**NOTICE OF DECISION TO CONSENT TO CHANGE TO PROPOSAL DURING
ASSESSMENT**

Yangibana Rare Earths Project
Assessment No. 2115

CONSENT TO CHANGE PROPOSAL DURING ASSESSMENT

Proposal: Yangibana Rare Earths Project

Figure 1: Changes to the tailings storage facilities and evaporation pond

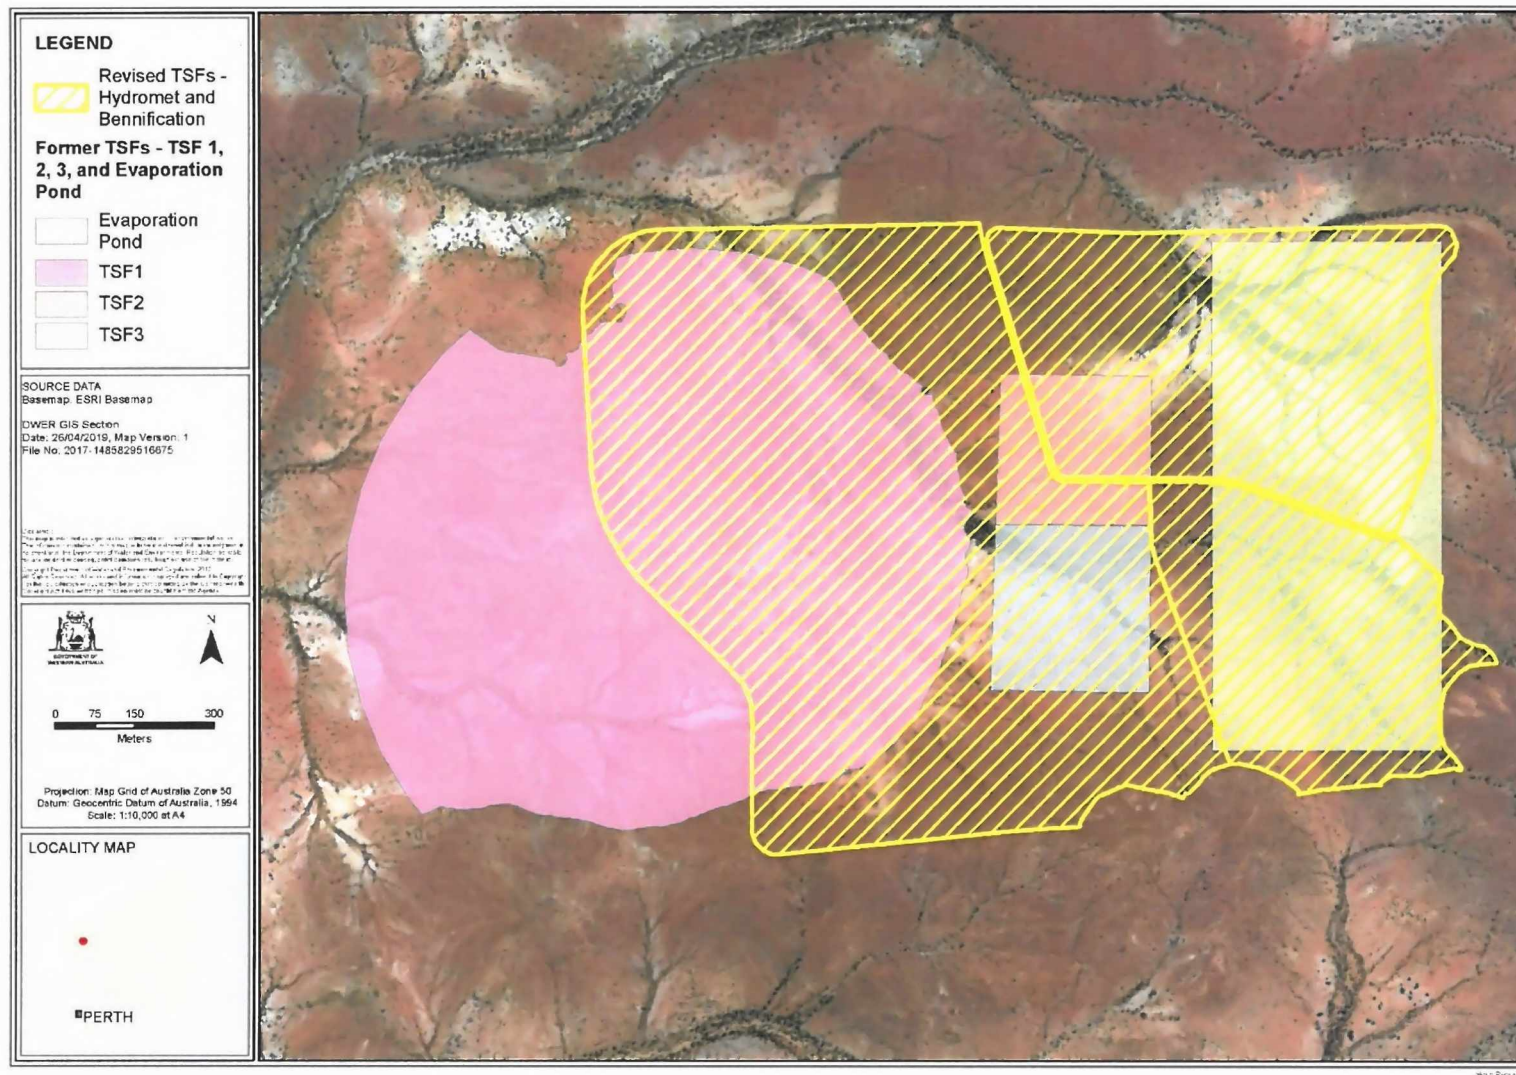
1. Combining tailings storage facilities (TSF) and evaporation pond;
 - TSF 1 and TSF 2 combined into the Beneficiation TSF
 - TSF3 and evaporation pond combined into the Hydromet TSF
2. Increase in capacity of TSF to;
 - 10 Mt in the Beneficiation TSF (TSF1 and TSF2)
 - 750,000 tonnes in Hydromet TSF (TSF3 and evaporation pond)
3. Change the deposition methodology of the Beneficiation TSF from central thickened discharge to perimeter discharge in a paddock style design.

These changes are illustrated in Figure 1 attached.

Figure 2: Changes to the tailings storage facilities and evaporation pond

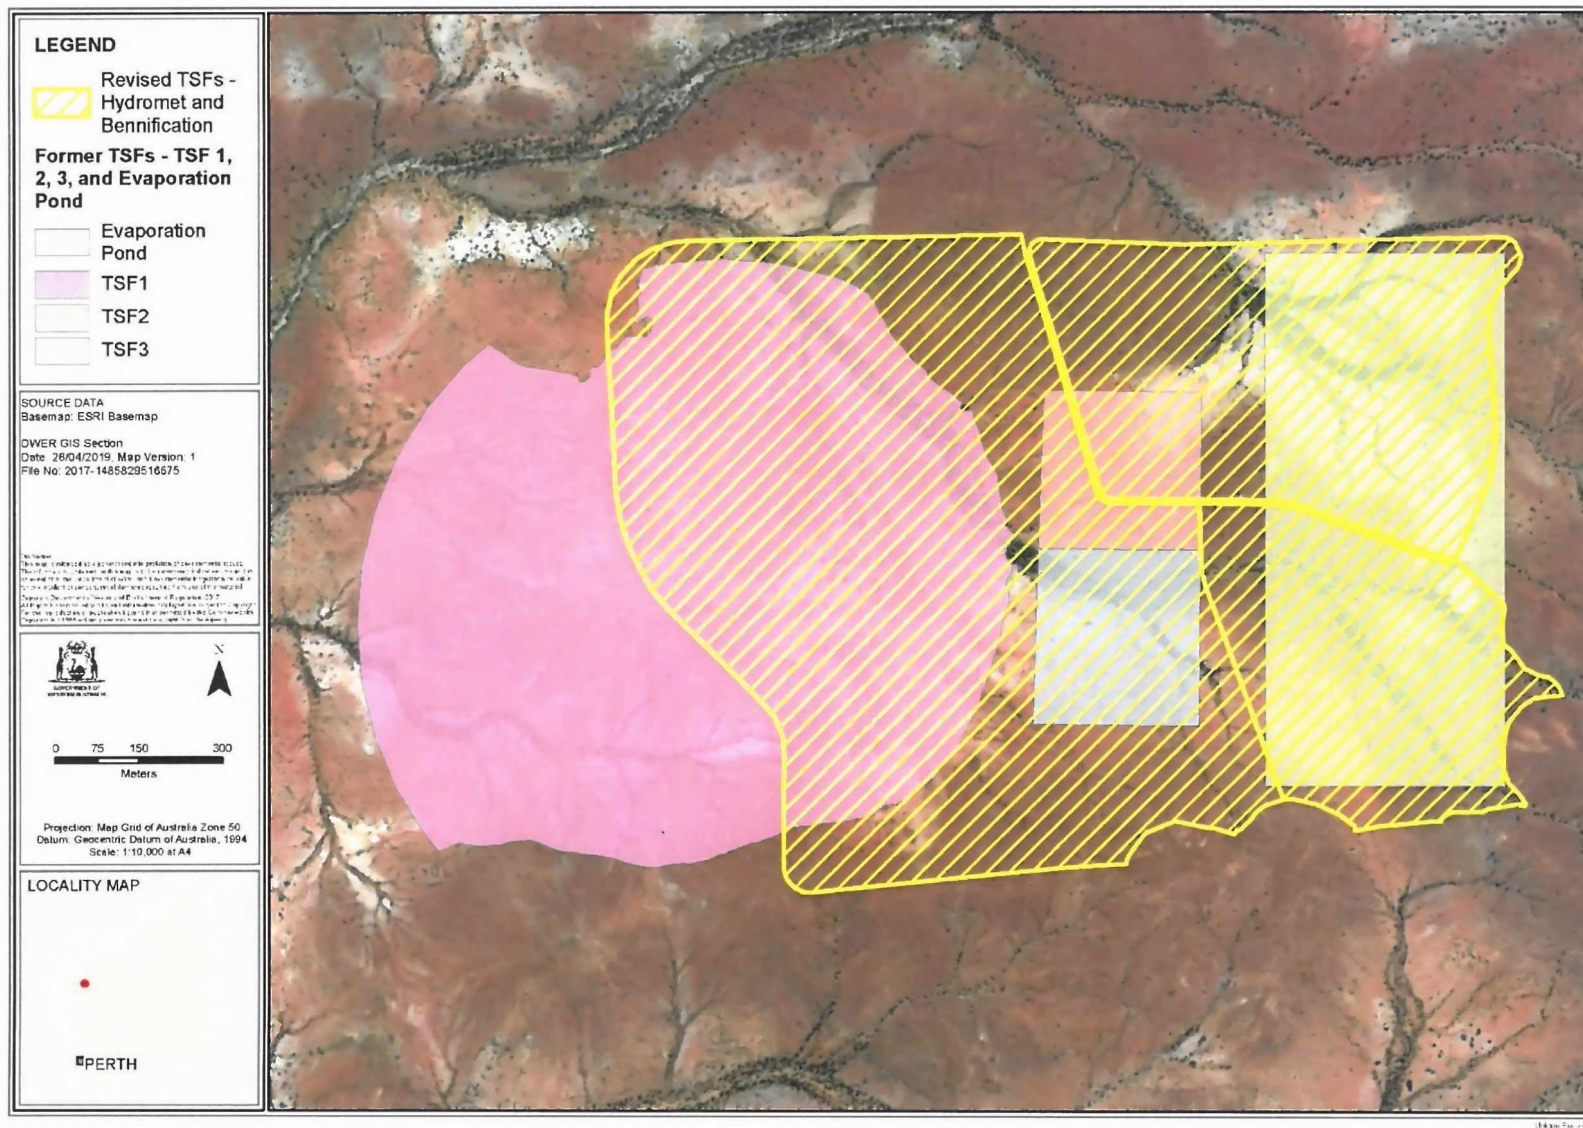
a) Combining tailings storage facilities (TSF) and evaporation pond:

- TSF 1 and TSF 2 combined into the Beneficiation TSF
- TSF3 and evaporation pond combined into the Hydromet TSF

The change in footprint is illustrated in the attached Figure 2.

- Flora and vegetation - The revised design does not require any additional clearing and will not increase impacts to the associated vegetation types. Based on the current information available the proposal is unlikely to increase impacts to significant flora species.
- Inland waters and terrestrial environmental quality - modelling undertaken for the Beneficiation TSF indicates that there is little change to the predicted seepage during operation with horizontal seepage reducing slightly and is still expected to remain within the TSF footprint. The design of the TSF will continue to maintain integrity over the long term (modelling undertaken for 1000 years).

Contaminants in the TSFs have been calculated and show that tailings in the Beneficiation TSF have an average radionuclide level of 0.8 Bq/g with rates up to 1.4 Bq/g for short periods during commissioning and ramp-up. The predicted levels prior to combination of TSF were less than 1 Bq/g for TSF 1 and 4 Bq/g for TSF2. It is predicted that elevated levels of ammonium hydroxide (6,4000 mg/L) will also be produced that may release ammonia gas. All other key elements remain the same as those predicted for the initial TSFs.
